REPORT OF ALTERATIONS TO DESIGNATED RESOURCE

Site Number/Address: 336 E. Magnolia Street
Laurel School National Register Historic District
ISSUED: April 21, 2021

This report is to document the summary of effects from proposed alterations to the Chris Horst House at 336 East Magnolia Street, pursuant to Fort Collins Municipal Code Chapter 14, [Article IV](#), made by the Landmark Preservation Commission at their April 21, 2021 meeting. A copy of this report may be forwarded to the Colorado Office of Archaeology and Historic Preservation.

Future vs. Existing Elevations

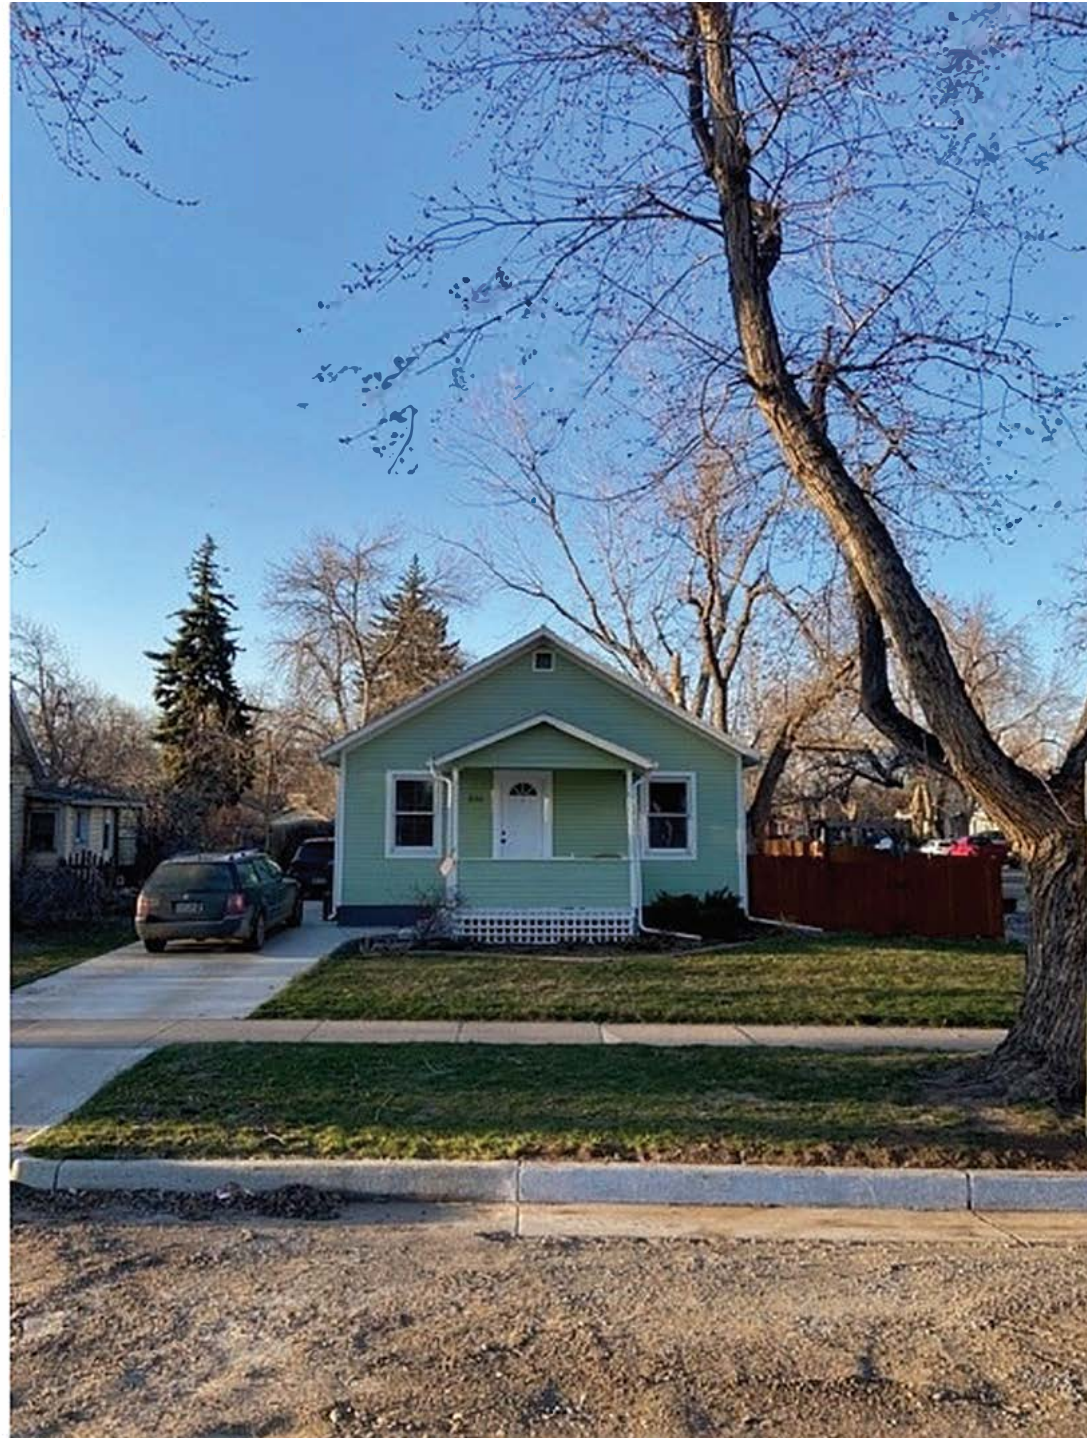
1. Two-story addition onto the building's north/rear elevation, including necessary demolition. Addition includes the modification of the historic front-gable into a gable-on-hip configuration, the addition of decorative shingling in the gable ends, and a rear second-story deck with a spiral stair.

- **Like most Minimal Traditional dwellings, the property is defined by its simple, one-story configuration and lack of ornamentation. The two-story addition is not compatible with the overall character of the property due to its incompatible size and massing, the introduction of the gable-on-hip configuration on the historic front gable, and the addition of decorative features like shingling in the gable ends that were rare on Minimal Traditional homes and not used on this property. The Standards would call for a single-story addition compatible with the historic massing and scale of the house, the use of basement-level excavation to capture more space if needed, and avoiding conjectural decorative features not characteristic of this type of home such as the decorative shingling or exterior spiral stair. This item does not meet this Standard.**

2. Demolition of the existing front-gabled porch and replacement with a full-width, partially covered porch with a hipped roof.
 - **Where they were built on Minimal Traditional homes, porches like that existing on this property were typically designed in the manner present, simple and front-gabled. While the proposed expansion of the porch deck beyond the porch cover is likely acceptable under the Standards, the demolition of the**

<p>existing porch framing and replacement with a hipped roof cover does not meet this Standard.</p> <ul style="list-style-type: none"> • 	
SOI #3	<p><i>Each property will be recognized as a physical record of its time, place, and use. Changes that create a false sense of historical development, such as adding conjectural features or elements from other historic properties, will not be undertaken.</i></p> <ol style="list-style-type: none"> 1. Two-story addition onto the building's north/rear elevation, including necessary demolition. Addition includes the modification of the historic front-gable into a gable-on-hip configuration, the addition of decorative shingling in the gable ends, and a rear second-story deck with a spiral stair. <ul style="list-style-type: none"> • The addition of features such as the decorative gabling create a false sense of history, suggesting this property was built during the late Victorian era as opposed to its 1938 Depression-era construction. The addition of an exterior spiral staircase on a residential property is not only highly irregular for historic properties in the United States, but is inappropriate considering that Minimal Traditional homes lacked ornamentation. This item does not meet this Standard. 2. Demolition of the existing front-gabled porch and replacement with a full-width, partially covered porch with a hipped roof. <ul style="list-style-type: none"> • Although demolition of historic features does not meet other Standards, the design of the new porch does not appear to create a false sense of history, although it should be noted that hipped roofs were rare on porches built onto Minimal Traditional homes in the 1930s and 1940s, and modification of this feature appears unnecessary considering the scope of the project. 	N

<p>should be retained as constructed. This item does not meet this Standard.</p> <ul style="list-style-type: none"> • 	
SOI #10	<p><i>New additions and adjacent or related new construction will be undertaken in such a manner that, if removed in the future, the essential form and integrity of the historic property and its environment would be unimpaired.</i></p> <ol style="list-style-type: none"> 1. Two-story addition onto the building's north/rear elevation, including necessary demolition. Addition includes the modification of the historic front-gable into a gable-on-hip configuration, the addition of decorative shingling in the gable ends, and a rear second-story deck with a spiral stair. <ul style="list-style-type: none"> • Due to the level of demolition necessary to construct the addition, this project is not reversible and will result in permanent damage to the historic integrity of this property. For this reason, additions onto, rather than overtop of, side or rear elevations are recommended under the Standards, similar to the existing 1992 addition on this property. This item does not meet this Standard. 2. Demolition of the existing front-gabled porch and replacement with a full-width, partially covered porch with a hipped roof. <ul style="list-style-type: none"> • While demolition of historic features is not recommended, the porch could be reconstructed to return the feature to its historic, front-gabled form. 	N
